POWER PLANT - GENERAL SERVICES HARNESS (LOOM D) - INTRODUCTION OF ICE DETECTION SYSTEM
ELECTRICAL HARNESS AND CLIPPING - CATEGORY CODE 7 - MOD.ENG-71-0187

V2500-ENG-71-0187

View of the position of additional cable
 Fig.5

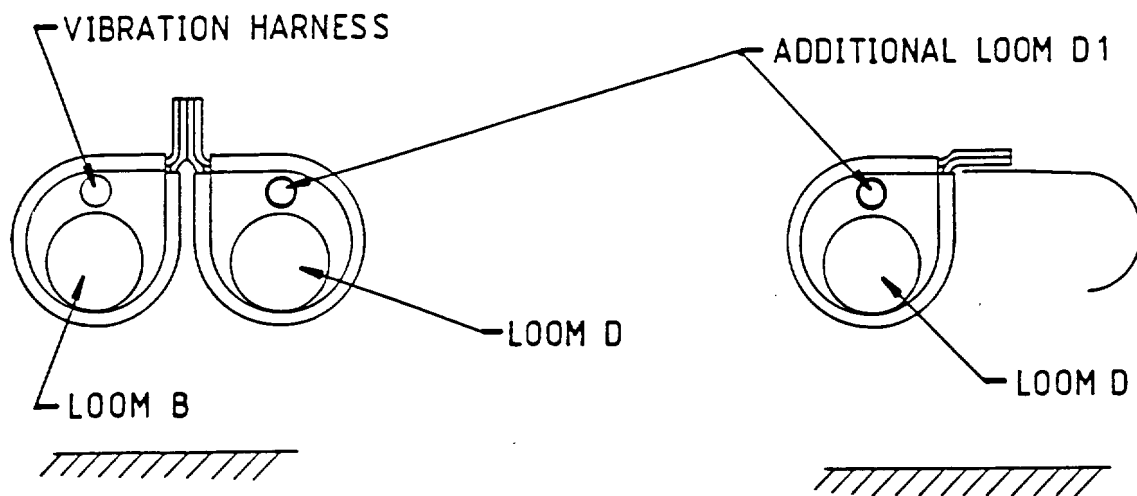
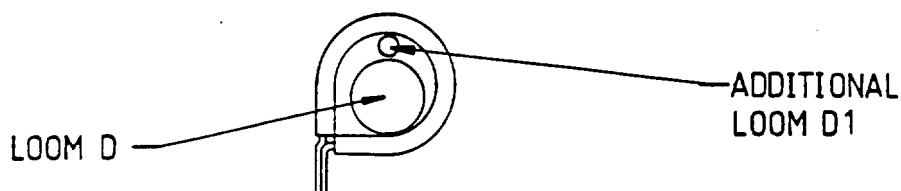
- (i) The quantity of contact pins at connector P1-869 has decreased from 10 to eight and at connector P1-873 from 24 to 20.
- (ii) The sealing plugs at P1-869 are deleted. At connector P1-873 the quantity has decreased from nine to five.
- (iii) Another harness assembly, Loom D1 has been added. This assembly has a connector (P1-8067) with 12 contact sockets, six sealing plugs, a backshell assembly and a bush. There are six cables each with a contact pin. Four of the pins connect to P1-873 and two connect to P1-869. The harness will be tied to Loom D. (Refer to Figure 5).

View of the position of additional cable
 Fig.6

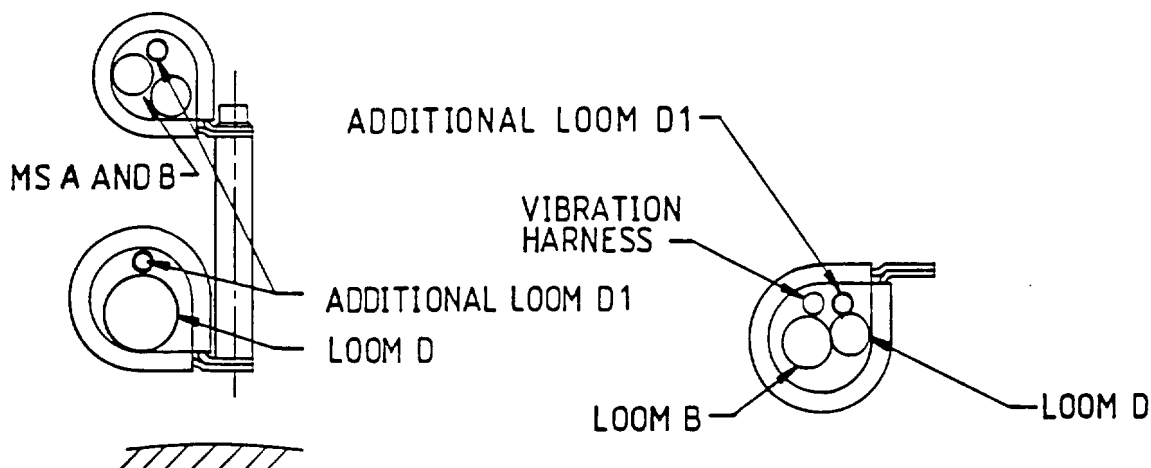
(b) The clip points that follow have changed:

CP2181, CP2253, CP2255, CP2260, CP2319, CP2320, CP2321, CP2322,
CP2323, CP2455, CP2458, CP2459, CP2460, CP2461, CP2462, CP2463,
CP2464, CP2465, CP2466, CP2467, CP2468, CP2469, CP2483, CP2487,
CP2489, CP2490, CP2548, CP2561, CP2591, CP2622, CP2623, CP2632.
